Objective Design Standards Self-Guided Site Tour

Summary of Feedback

September 2021

This document summarizes the feedback provided by the Planning Commission and members of the public in response to an online questionnaire intended to accompany a self-guided tour of recently constructed housing development projects throughout Pleasanton.

The pattern of street/building/alley/building paseo building represents quality site planning.

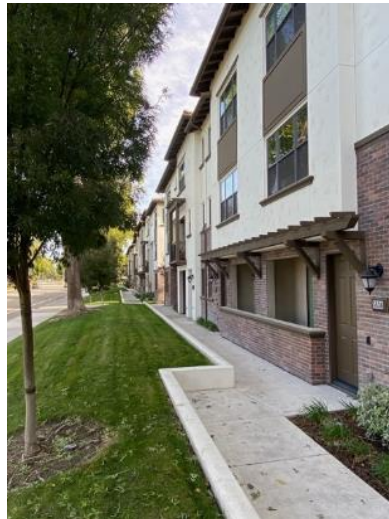
These rowhomes easily fit into the commercial area.

- The rowhouse development maintains the typical desired structure of street/building/alley/building/ paseo building and so forth. A perimeter drive includes fire department access as well as additional parking.

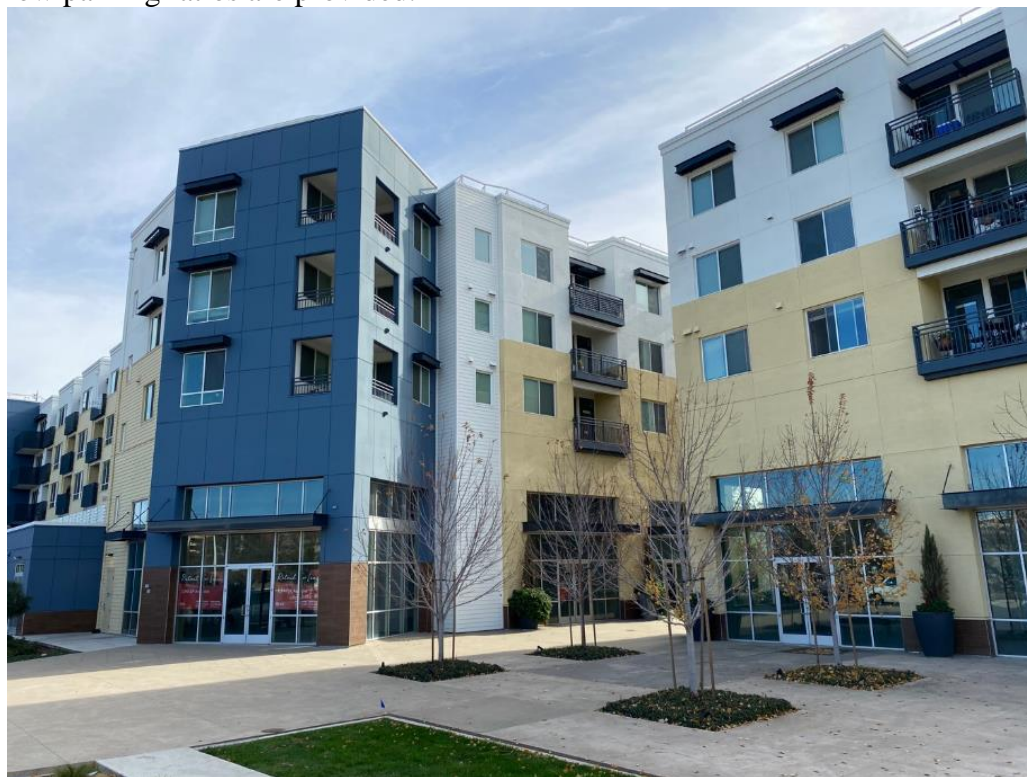
- The corner POPOS retail plaza is appropriately located at crossing to the BART station. The retail has tall spaces and transparent storefronts. In this location, retail needs to provide parking to sustain it. The diagonal parking on street parking was meant to be open for retail use and convenient lunch and pick up rather than residential or BART parking. However, it appears that the parking is taken up by residents. More attention may need to be paid to including enforceable standards for parking management within these residential projects, particularly where relatively low parking ratios are provided.

In person, the plaza lacks seating and gathering areas to support retail and make it more attractive to restaurants or lunchtime destinations. Other plazas on this tour demonstrate a greater level of programming, placemaking, and detail.

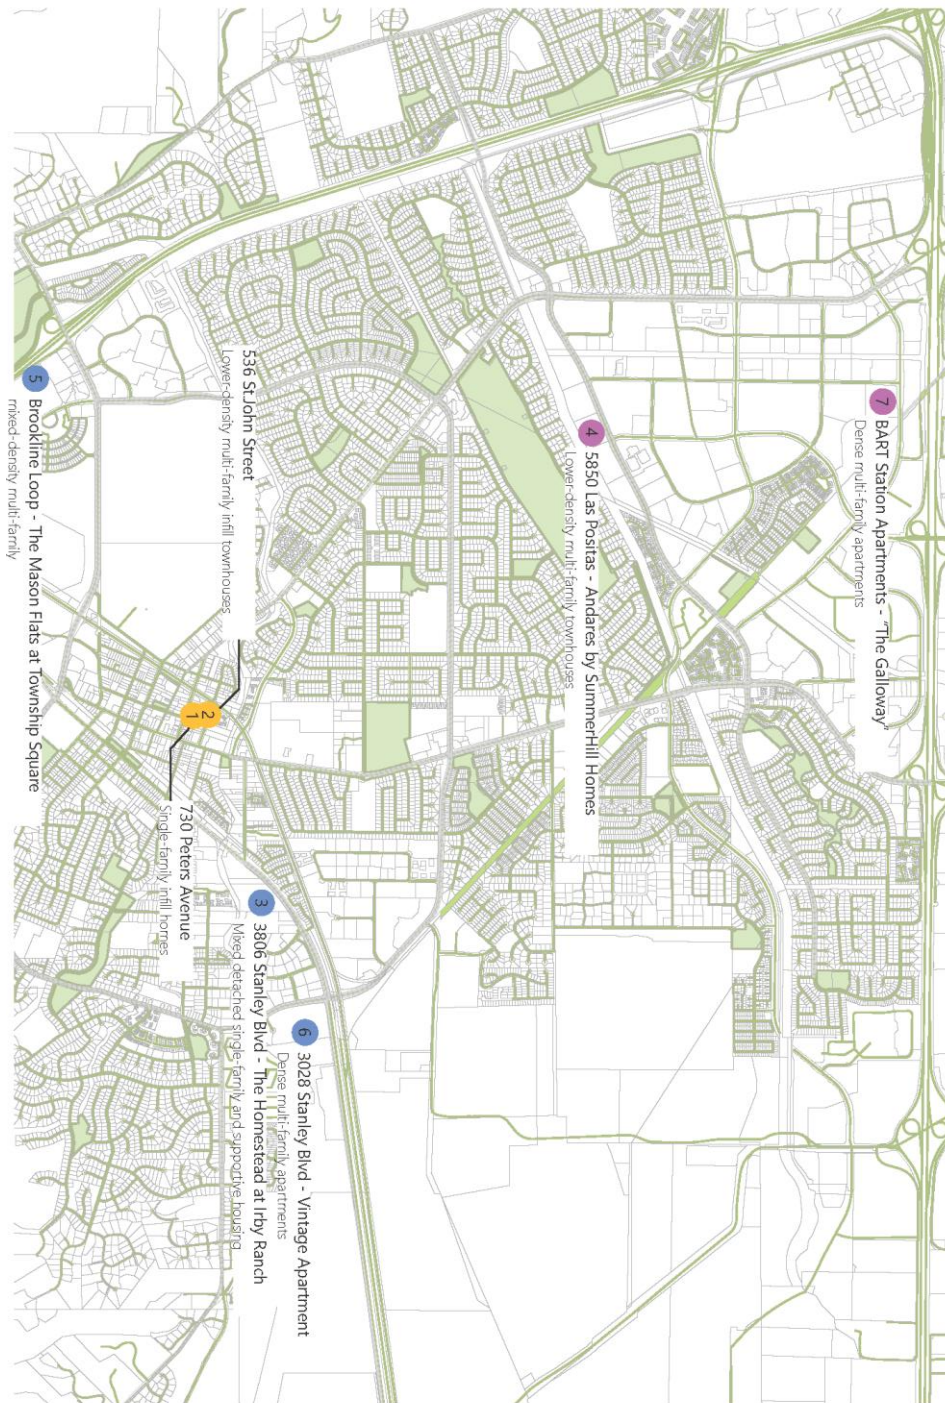
- The facades provide variation in material and colors, however the variations lack a “change in plane” (the projections or insets of portions of the building face relative to one another). Design standards and guidelines typically include this requirement so as to create articulation and draw a clear definition between different elements and features.

One can see that there is very little change in plane which most communities define as 2 feet to change colors and materials. On the mixed use building the yellow, white board siding and white stucco are all within the same approximate surface. 6 inches is generally not accepted as a plane change. The result is that the buildings visually lack depth and may be perceived to appear substandard or of lesser quality.
